**7.5** **101 SALMON STREET, PORT MELBOURNE (3/2014/MPA/A)**  
**LOCATION/ADDRESS:** **101 SALMON STREET, PORT MELBOURNE**  
**EXECUTIVE MEMBER:** **LILI ROSIC, GENERAL MANAGER, CITY STRATEGY AND SUSTAINABLE DEVELOPMENT**  
**PREPARED BY:** **BRAD FOLETTA, PRINCIPAL PLANNER FISHERMANS BEND  
SIMON GUTTERIDGE, PLANNING TEAM LEADER FISHERMANS BEND**

1.1 To provide a Council position on Ministerial Application 2014/002000-1 at 101 Salmon Street, Port Melbourne, to amend the existing permit under Section 72 of the Planning and Environment Act 1987 including the alteration of plans, permit conditions and permit preamble.

Figure 4: Front and rear elevation of proposed amendment plans, previous built form shown in via red outline.

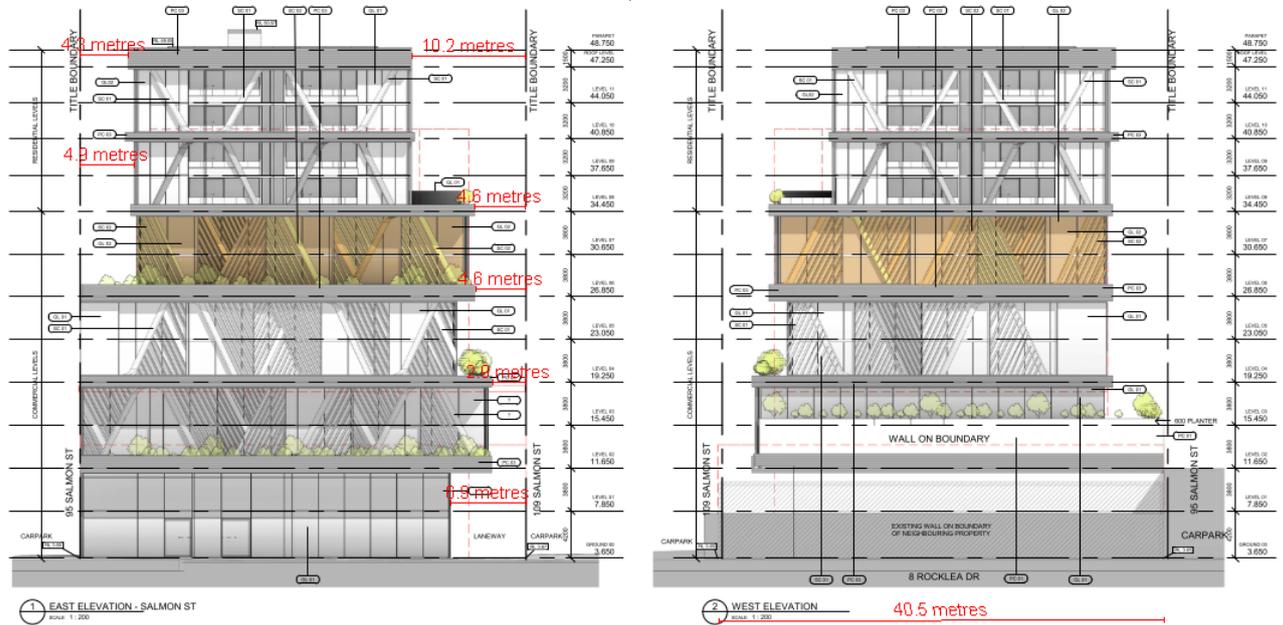
- 2.11 The proposed building whilst still 12 levels, would be 7.6m higher than the maximum height of the previously approved tower, and 15.1m and 4 levels higher than the 30m (8 storey) preferred maximum building height for the site introduced by Amendment GC81 in October 2018. The additional height is sought in part to accommodate adaptable floors within the podium, and the change from predominantly residential use to Office use in the tower (Commercial floor to floor heights are typically greater than residential floor heights because of the need to accommodate services above false ceilings).

11.4-4 The proposed building whilst still a maximum of 12 storeys, would be 7.6m higher than previously approved, and four storeys and 15.1m higher than the 30m (8 storey) preferred maximum height specified in the FB Framework Plan October 2019 and DDO33.

Five (5.0) metres of this additional height is a result of the amended plans increasing floor to floor heights in the podium levels to meet new adaptable building requirements.

A further 1.3m of the additional height is a result of increased floor to floor heights in the tower levels to accommodate the change from Dwelling use to Office use (Noting typical commercial floor to floor heights are greater than typical dwelling floor to floor heights because of the need to accommodate building services above false ceilings) and to improve amenity, and the final 1.3m additional height is a result of a revised rooftop parapet design.

**Figure 11.13-1:** Extent of shadow at 11am on 22 September equinox. (Blue hatched line = previous extent of shadow. **Red bold hatched line = site boundary.** Red hatched line = max. shadow pursuant to Table 2 of Clause 2.6 of DDO33 - Not applicable to linear park)

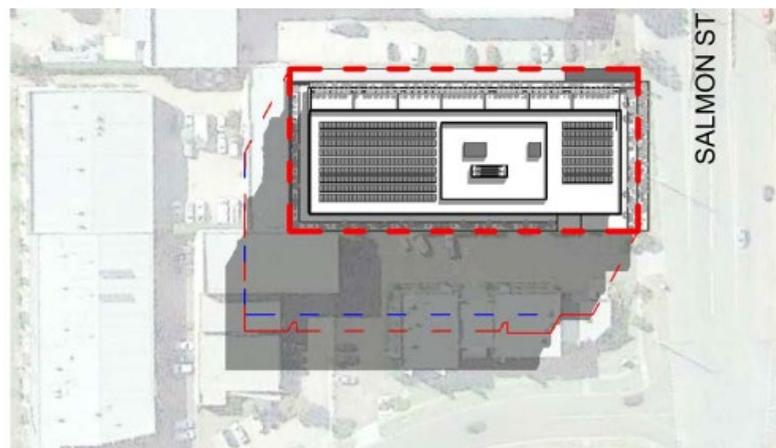
The amended proposal would not overshadow the Wirraway North park, but would cast some shadow over the linear park, and so would comply with the Scheme.
